**City of Kingston
Planning Committee
Meeting Number 01-2024
Addendum**

**Thursday, December 7, 2023 at 6:00 p.m.
Hosted at City Hall in Council Chamber**

- a) Correspondence received regarding 2312 Princess Street, (File Number D35-004-2022), dated November 20 – 30, 2023.**

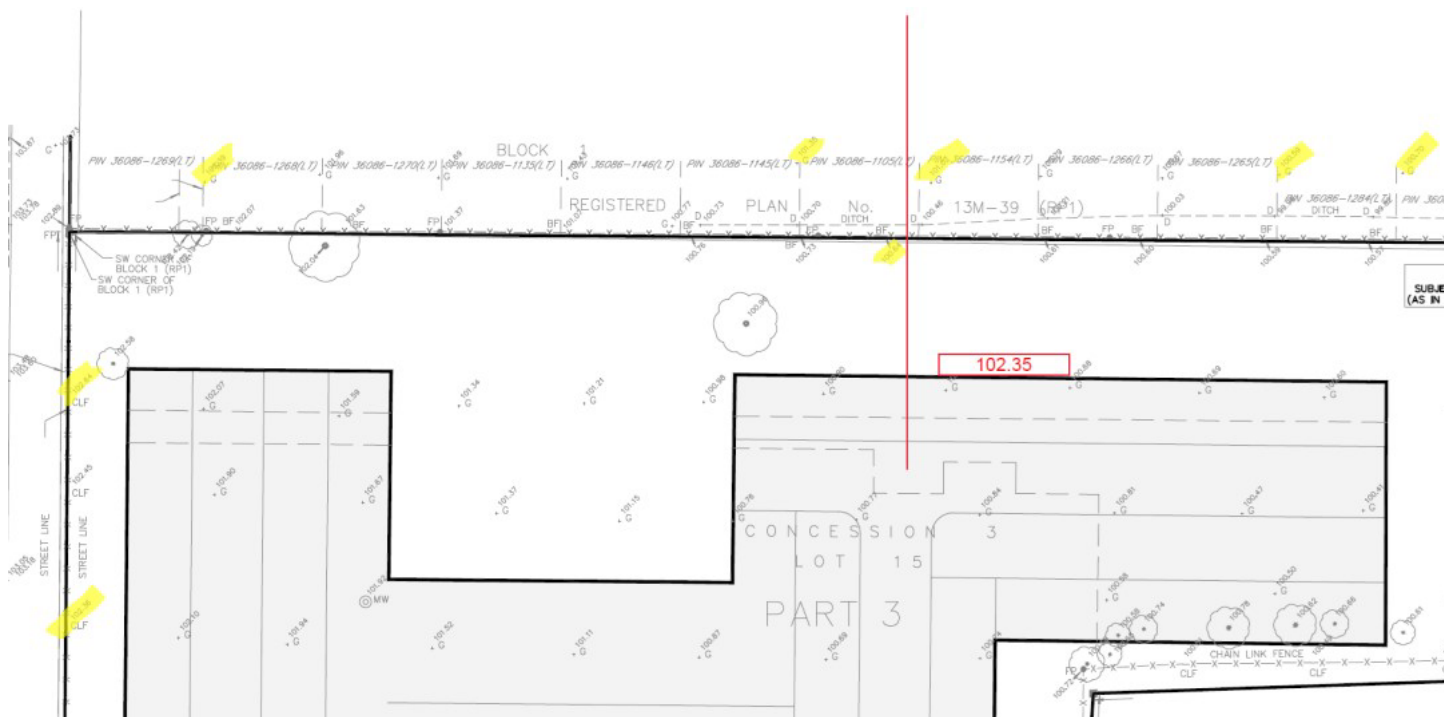
3. The increase in elevation of the building will affect each residence on Ellesmeer Ave in a different way. The sight plan submitted only shows one residence and does not give a good representation of the residences on the north side. Each residence has a different grade down to the fence line. The west end is much higher than the east end, therefore the sight lines would be much different. The developer should provide a more comprehensive sight line proposal that shows all the residences and how this increased height will affect them. The fence at 2.3 m will do nothing for privacy. As shown in the diagram even the person on the 2nd floor will have a clear sight line into the adjoining back yard. Trees will take several years to provide any privacy unless the developer is providing mature trees behind each residence.

Thank you for providing the overlay. It certainly helps to put it in perspective. Although I see that there will be a balcony looking directly into our backyard. A lot of the trees that are currently along the fence line are slated to be removed which will open up the sightline further.

- c. I took the liberty of overlying the building plan on top of the site plan and an aerial image. Provided below, it highlights that 7 balconies project to the 13 residential lots which abut the north lot line. While there will be some difference between the individual lots, the one cross section is generally representative and, as highlighted in the answer to 1 above, is similar in impact of a typical residential unit. While the vegetative barrier along the north lot line will take time to mature, over time any impact will be further mitigated.
<image001.png>
